MILITARY SPECIFICATION

MICROCIRCUITS, DIGITAL, BIPOLAR, LOW-POWER SCHOTTKY TTL,
PRIORITY ENCODERS, MONOLITHIC SILICON

This amendment forms a part of Military Specification MIL-M-38510/360A, dated 26 August 1983, and is approved for use by all Departments and Agencies of the Department of Defense.

FIGURE 5. Switching tests.

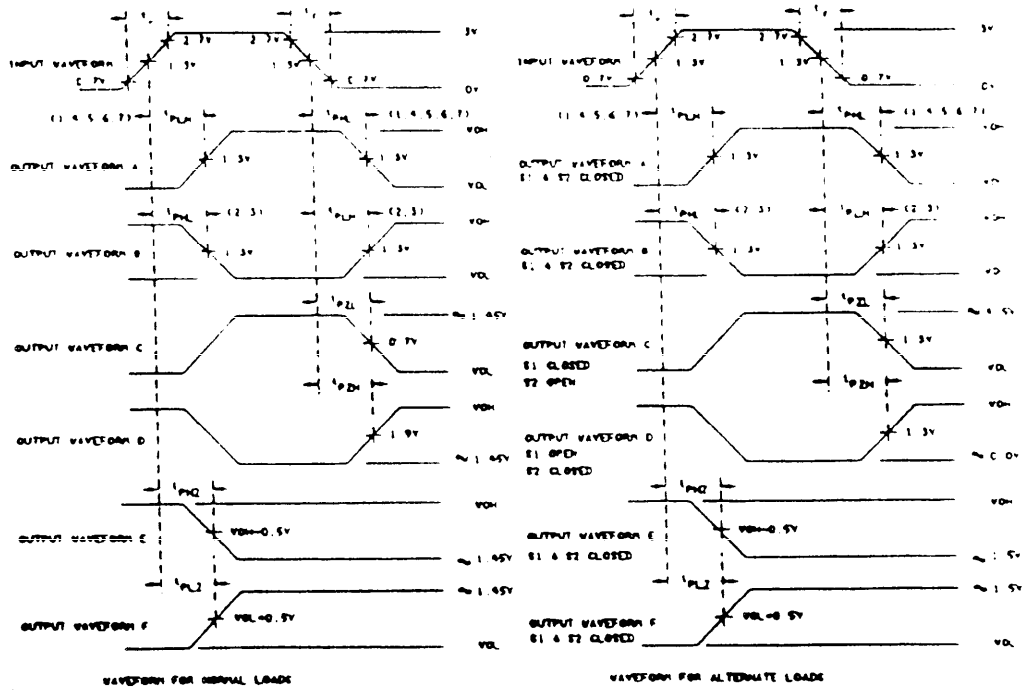
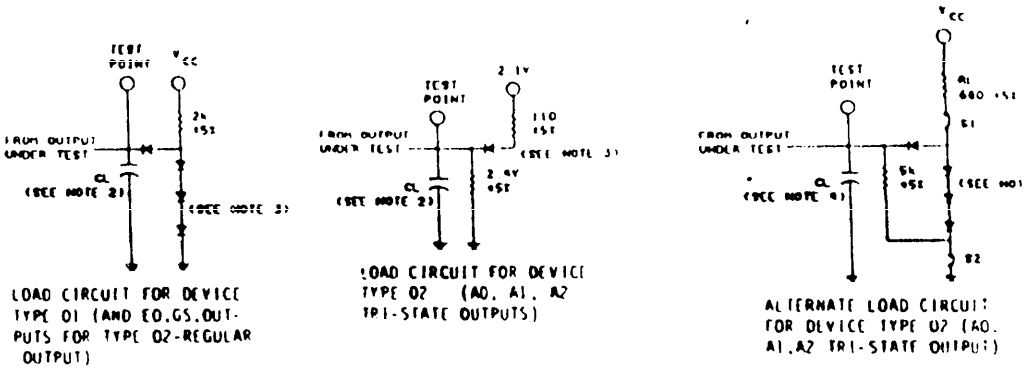
FIGURE 5: Delete and substitute new figure 5 printed on page 3 of this amendment.

* FIGURE 5: Delete "(AND EO, GS, OUTPUTS FOR TYPE 02 REGULAR OUTPUT)" under LOAD CIRCUIT FOR DEVICE TYPE 01 as it appears in Amendment 2.
* FIGURE 5: Delete "(A0, A1, A2 TRI-STATE OUTPUTS)" and substitute "(ALL OUTPUTS)" under LOAD CIRCUIT FOR DEVICE TYPE 02, as it appears in Amendment 2.

NOTES:
1. Input pulse characteristics: PRR ≤ 1.0 MHz, tr ≤ 15 ns, and tf ≤ 6 ns.
2. For normal load C1 = 50 pF ± 10%
   Cl includes probe and jig capacitance.
3. All diodes and 1N3064 or 1N916.
4. For alternate load C1 = 50 pF ± 10% for t_{PLH}, t_{PHL}, t_{PZL}, and t_{PZH};
   CL = 15 pF min. for t_{PHZ} and t_{PLZ}.
   CL includes probe and jig capacitance.
5. Load circuits on a given output are only required where the specific test given in table III indicates "OUT" on that output. Load circuits may otherwise be omitted.
